<b>Interview Summary</b>	Application No. <b>09/808,686</b>	Applicant(s) <b>Watson</b>
	Examiner <b>Clark F. Dexter</b>	Group Art Unit <b>3724</b>

For: PRECISION ELECTRIC MITER BOX \*

## A M E N D M E N T

Fig 1

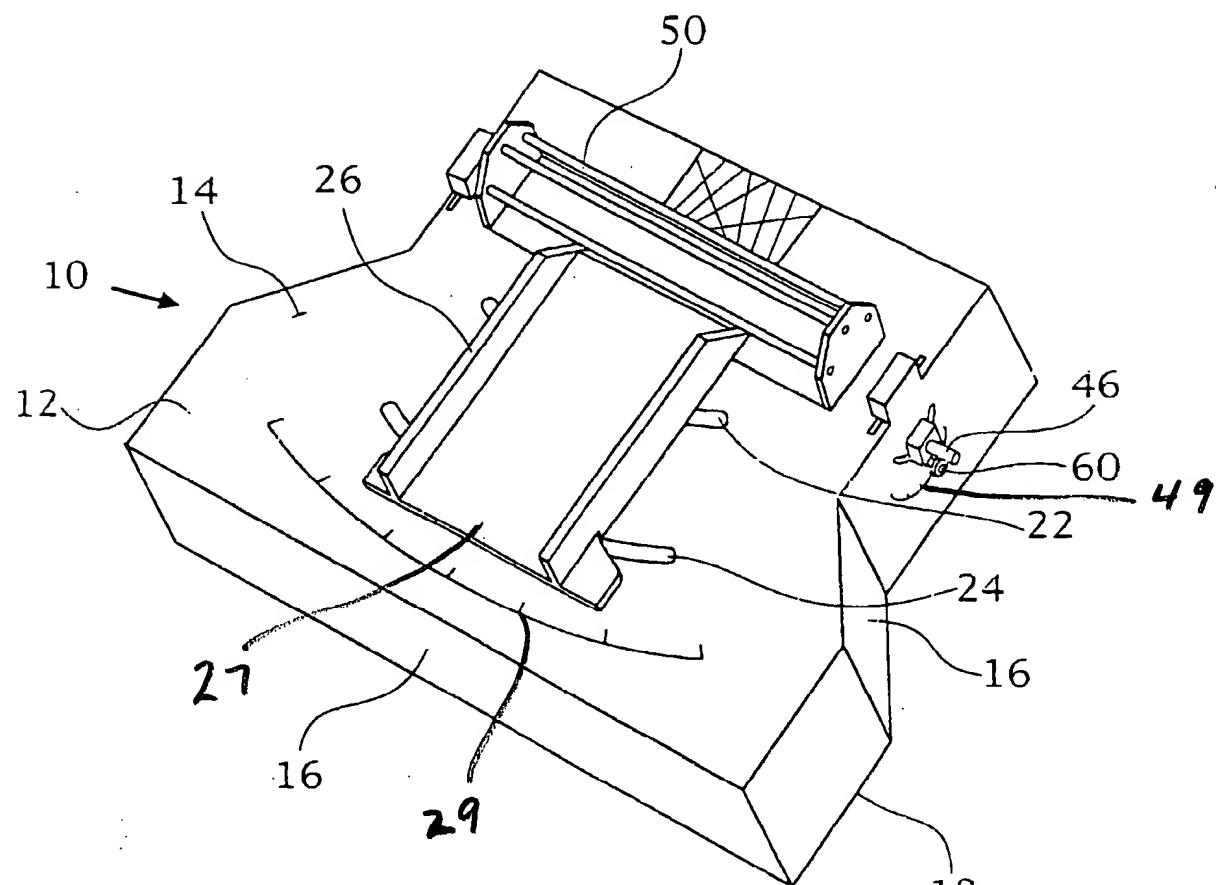
Enclosed herewith is a Letter To The Official Draftsman (in duplicate) for proposed amended drawings of FIGS. 1, 3, 4, 10, 11, 16, 21 and 22.

The drawings were objected to because of several informalities. The drawings have been corrected as shown in the red markings to add numerals or to correct numerals as suggested by the Examiner. A duplicate copy of the red marked FIGS. 1, 3, 4, 10, 11, 16, 21 and 22 are enclosed to a Letter To The Official Draftsman. Also enclosed are formal drawings incorporating the corrections. Also, two sheets of drawings were submitted which included FIGS. 20-22. Please cancel the sheet of drawings which show FIGS. 20-22 and retain the sheet of drawings showing FIGS. 20-24.

Fig 3

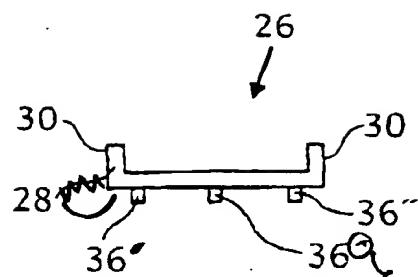
The proposed amendment was discussed. Mr. Gamson stated that Figures 3-9 were still not accurate and proposed additional changes in the interview. Mr. Dexter stated that these additional changes will be further considered upon receipt of the formal amendment.
